**FINAL FINDINGS AND DECISION BY THE LANDMARKS COMMISSION RENDERED ON August 24, 2020**

**CASE FILE NUMBER: LU 20-124363 HR AD  
PC # 19-261700**

**FLATWORKS BUILDING**

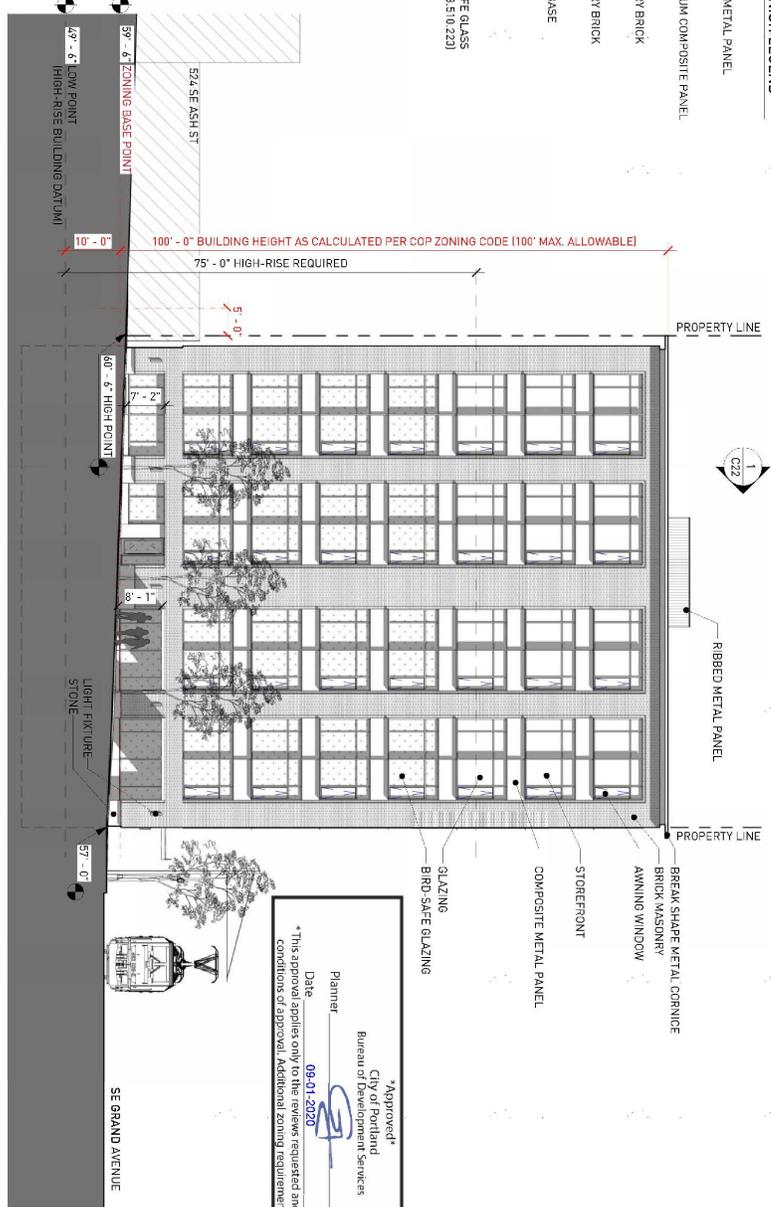
- North Elevation. Add dimension to eastern most bay. Because the headers at the two eastern bays appear quite low, it may be more successful to treat the glazing as “windows” rather than “storefronts”.

- North Elevation. Dimensions have been added to the underside of the headers and canopies. Because the headers at the two eastern bays are quite low, the glazing has been moved to the property line, rather than recessed like the other bays, treating them more like “windows” rather than “storefronts”.

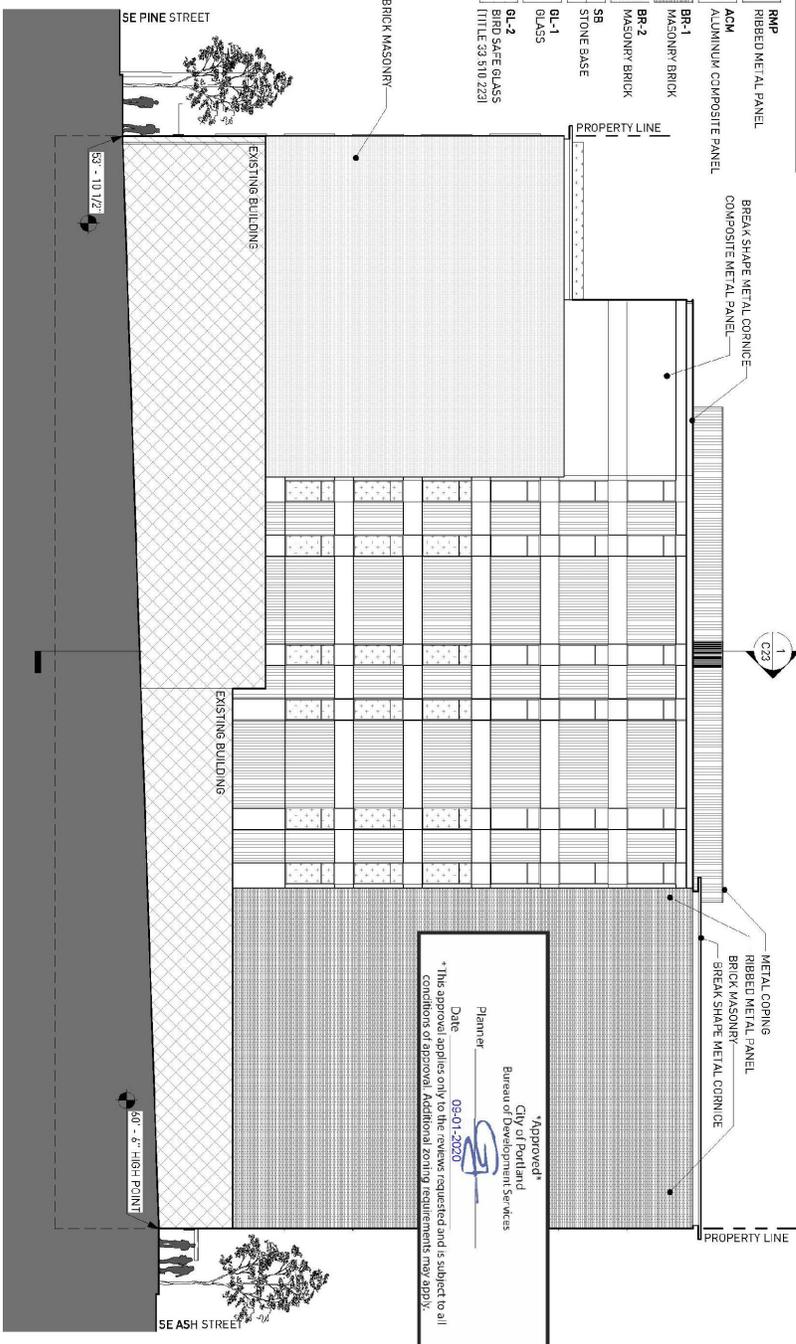
- Storefronts. Study whether the storefronts without entries can also be recessed, as shown in the renderings.
  - Granite base. Change drawings to reflect proposed granite slab treatment on elevations.

- West Elevation, Ground Level. The storefronts, bulkheads and granite at the base of piers all need a more consistent approach, especially on the light colored 6-story mass.

- West Elevation, Main Entry. Look into whether the main canopy can be more differentiated from the other canopies.
  - West Elevation, Spandrels at recess. Change elevations to show the wider metal spandrels at the recess, as shown in the renderings.

- The second hearing was held on August 24, 2020. In response to Commission’s concerns, the following revisions were made:
  - Storefronts. All storefront bays have been recessed 3 feet, except at the two eastern bays on the north elevation.

- Granite base. The drawings have been revised to reflect the proposed granite slab treatment on the elevations.
  - West Elevation, Ground Level. The ground level design has been revised to show a more consistent approach to the storefronts, bulkheads, granite at the base of piers and canopies.

- West Elevation, Main Entry. The main canopy has been raised above the transoms to better differentiate it from the other canopies.
  - West Elevation, Spandrels at recess. The elevation has been revised to show the wider metal spandrels at the recess.
